ENGINEER'S DRAINAGE CERTIFICATION - TEMPORARY C.O. FOR BUILDINGS 1-3

Engineer's Drainage Certification — Permanent C.O. For Buildings 1—4

### CITY HYDROLOGY FILE F16/D3E2

ENGINEER'S DRAINAGE CERTIFICATION
INTERSTATE COMMMERCE CENTER

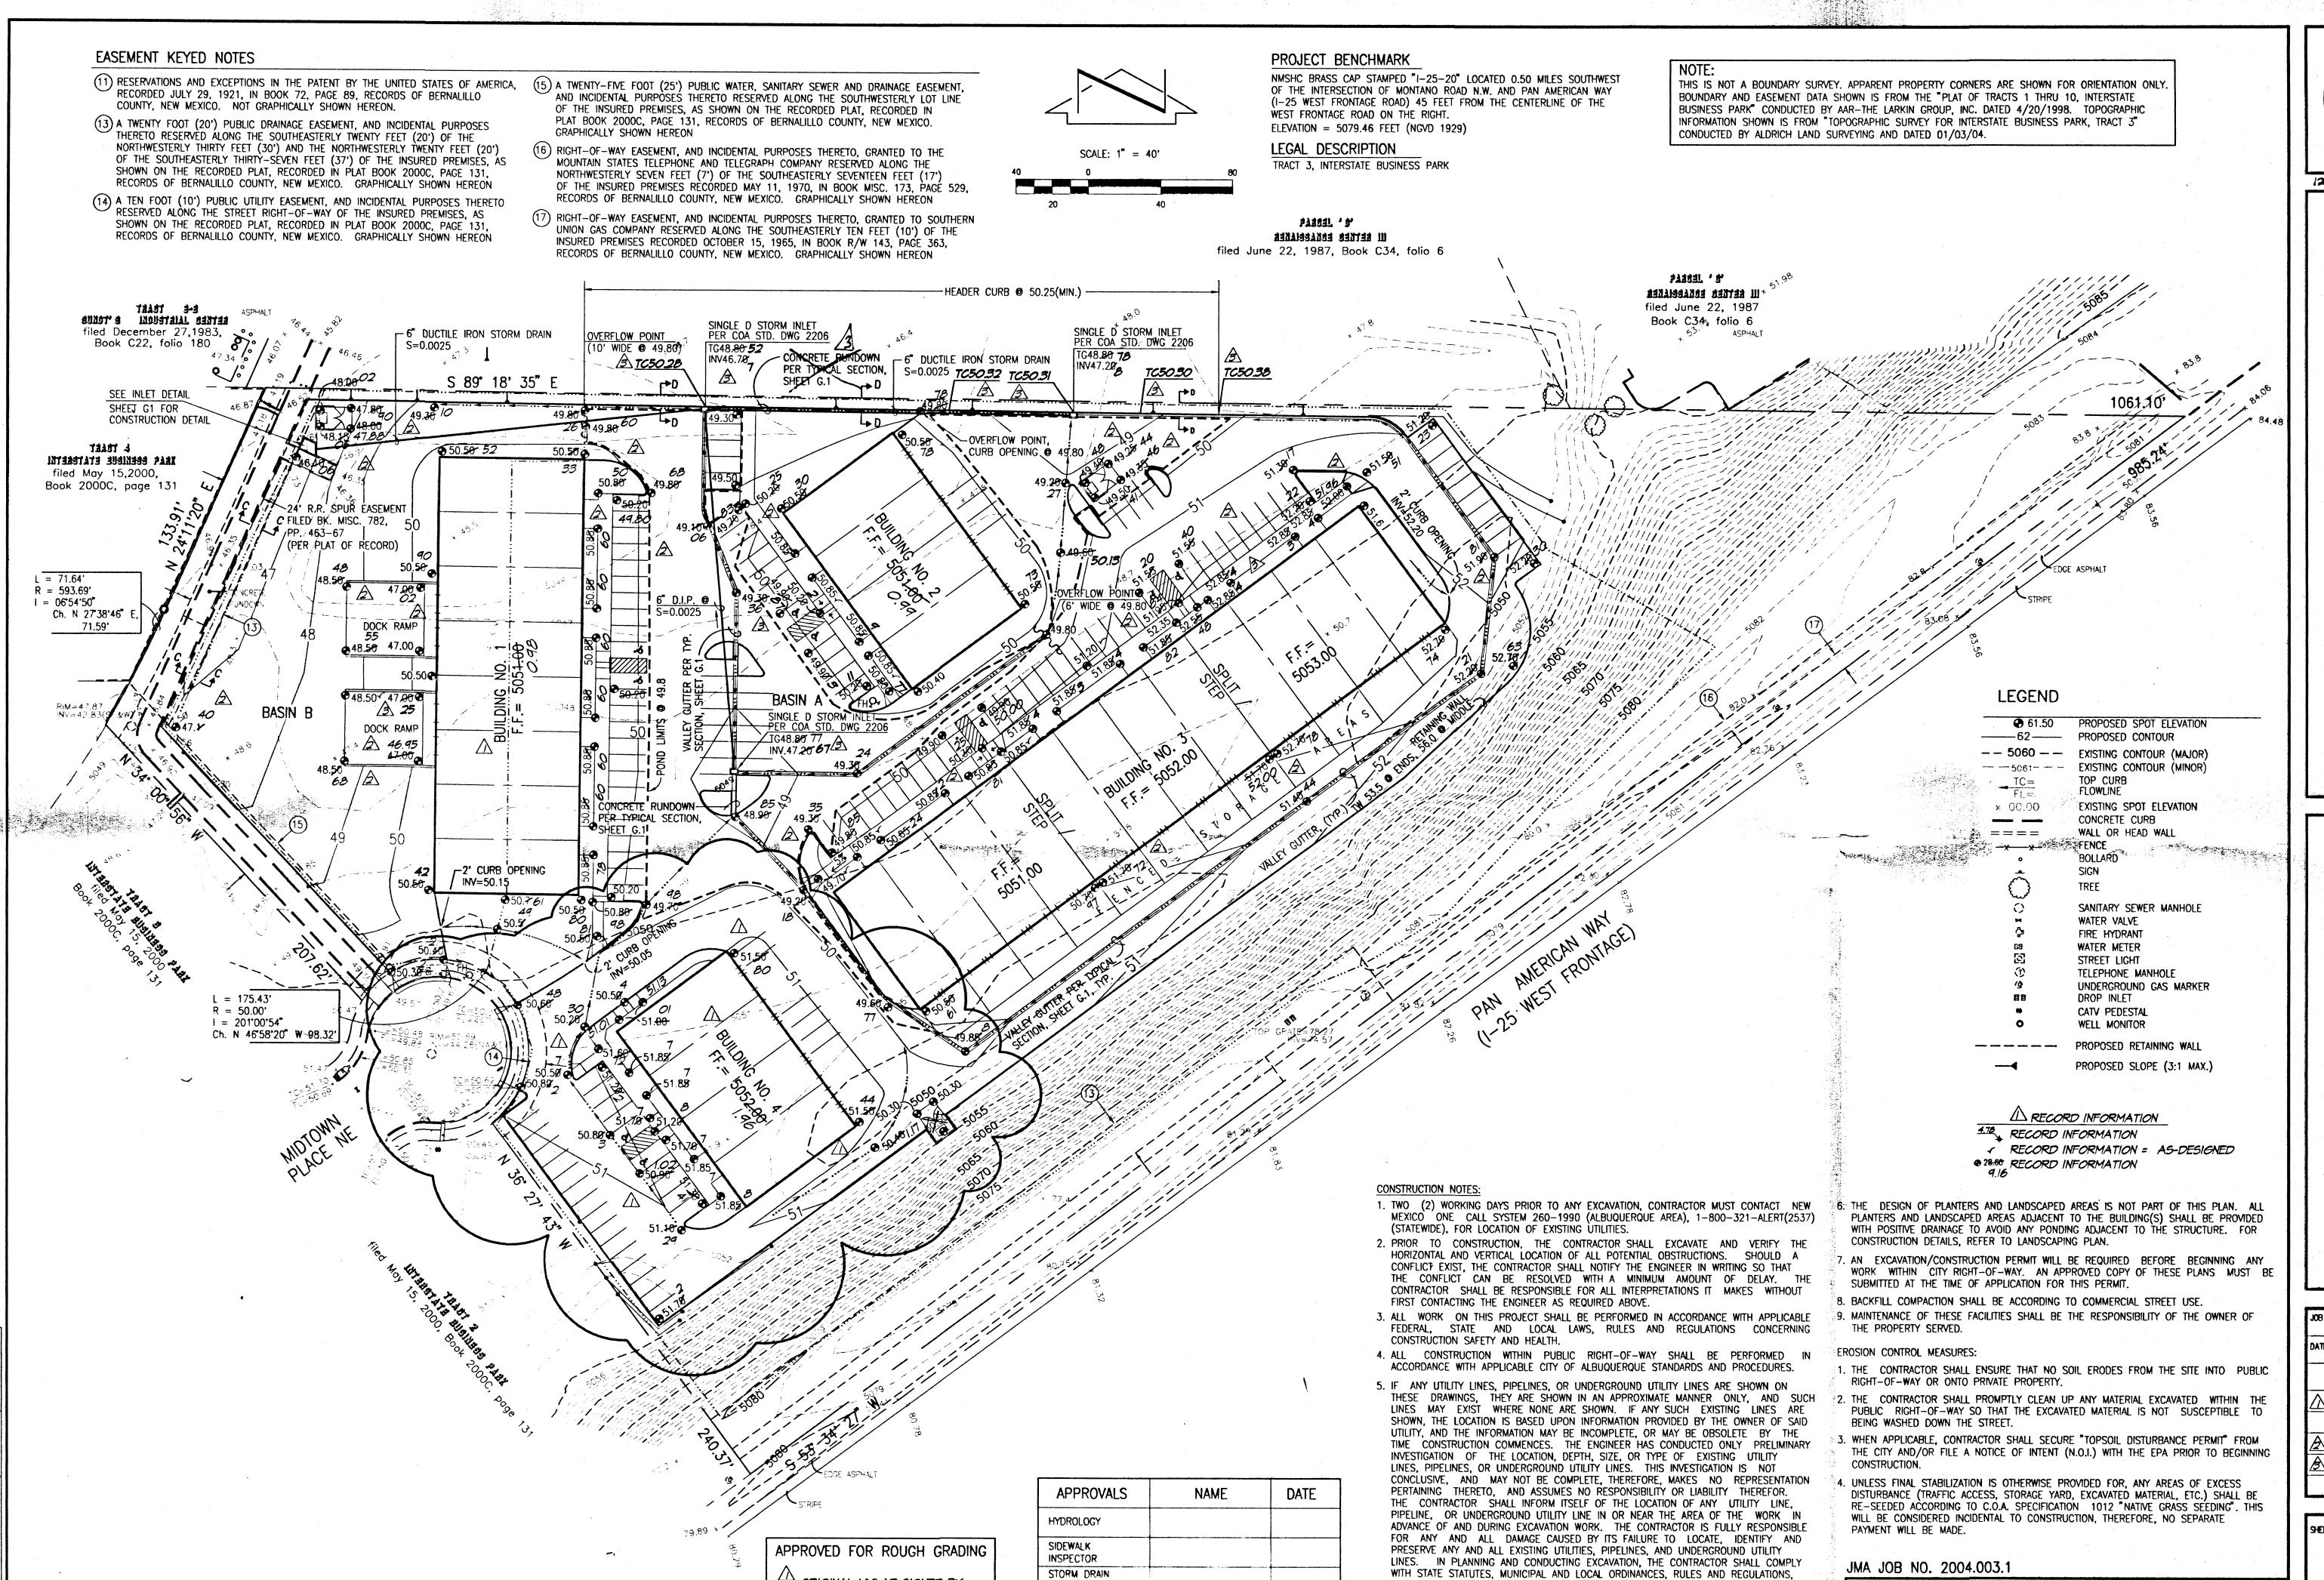
THE FOLLOWING ITEMS NEED TO BE ADDRESSED PRIOR RECERTIFICATION IN SUPPORT OF PERMANENT CERTIFICATES OF OCCUPANCY:

- 1) RECORD INFORMATION MUST BE REVIEWED AND EVALUATED FOR THE STORM INLETS AND STORM DRAIN. AS DETERMINED BY VISUAL INSPECTION, THESE ITEMS HAVE BEEN CONSTRUCTED, BUT ELEVATION DATA WAS NOT PROVIDED BY THE SURVEYOR AND THEREFORE WAS NOT EVALUATED AS PART OF THIS CERTIFICATION. THE PROJECT SURVEYOR HAS INDICATED THAT THEY WILL PROVIDE THIS INFORMATION.

- 2) THE CONNECTION TO THE EXISTING PUBLIC DRAINAGE CHANNEL MUST BE INSPECTED AND APPROVED BY STORM DRAIN MAINTENANCE. ALTHOUGH THE CONNECTION WAS MADE AT THE EDGE OF THE PUBLIC DRAINAGE EASEMENT (NOT WITHIN IT) TO AN EXISTING RIBBON CHANNEL PREVIOUSLY CONSTRUCTED UNDER WORK ORDER TO SERVE THIS SITE, MR. GLEN JURGENSEN REQUESTED AT THE TIME OF PLAN APPROVAL THAT THE POINT OF CONNECTION BE INSPECTED. THE CONTRACTOR, THS CONSTRUCTION, HAS INDICATED THAT THEY WILL CONTACT STORM DRAIN MAINTENANCE FOR AN INSPECTION.

- 3) RECORD INFORMATION MUST BE EVALUATED FOR THE HEADER CURB ALONG THE NORTH PROPERTY LINE. THIS CURB MUST MAINTAIN A MINIMUM PROPERTY LINE ELEVATION TO PROVIDE THE REQUIRED DETENTION POND VOLUME. ELEVATION DATA WAS NOT PROVIDED BY THE SURVEYOR, AND BASED ON VISUAL INSPECTION, THIS CURB WAS INDEED CONSTRUCTED, BUT DOES NOT APPEAR TO HAVE THE REQUIRED HEIGHT AT SOME LOCATIONS, POTENTIALLY ALLOWING OVERFLOW TO THE NORTH. THE PROJECT SURVEYOR HAS INDICATED THAT THEY WILL PROVIDE RECORD INFORMATION, AND THE CONTRACTOR HAS INDICATED THAT HE WILL HAVE THE CURB HEIGHT. RAISED IF ANALYSIS DETERMINES THAT IT IS NECESSARY.

THE FOLLOWING DEVIATION TO THE APPROVED WAS NOTED THAT DOES NOT ADVERSELY IMPACT SITE DRAINAGE OR THE ABILITY TO RECOMMEND PERMANENT CERTIFICATE OF OCCUPANCY:

1) THE OVERFLOW CONCRETE RUNDOWN ALONG THE NORTH PROPERTY LINE NORTH OF BUILDING 2 WAS NOT CONSTRUCTED. THIS WAS A SECONDARY OVERFLOW POINT (THE MAIN OVERFLOW POINT IS IN THE PAVEMENT SOUTHEAST OF THE SE CORNER OF BUILDING 2) AND ITS DELETION WILL NOT ADVERSELY IMPACT SITE DRAIANGE.

THE FOLLOWING ITEMS, PREVIOUSLY IDENTIFIED AS DEFICIENCIES AND REQUIRING RECERTIFICATION, HAVE BEEN ADDRESSED AS FOLLOWS:

- 1) RECORD INFORMATION HAS BEEN PROVIDED, REVIEWED AND EVALUATED FOR THE STORM INLETS AND STORM DRAIN. THEY WERE FOUND TO BE IN SUBSTANTIAL COMPLIANCE WITH THE APPROVED DESIGN.
- 2) THE CONNECTION TO THE EXISTING PUBLIC DRAINAGE CHANNEL WAS INSPECTED AND APPROVED BY GLEN JURGENSEN FROM STORM DRAIN MAINTENANCE. HE CONFIRMED THIS IN A TELEPHONE CONVERSATION DECEMBER 9, 2004.
- 3) AS DEMONSTRATED BY THE ADDITIONAL RECORD INFORMATION PROVIDED BY THE SURVEYOR DECEMBER 10, 2004, THE CURB ALONG THE NORTH PROPERTY LINE HAS BEEN RAISED TO THE REQUIRED ELEVATION.
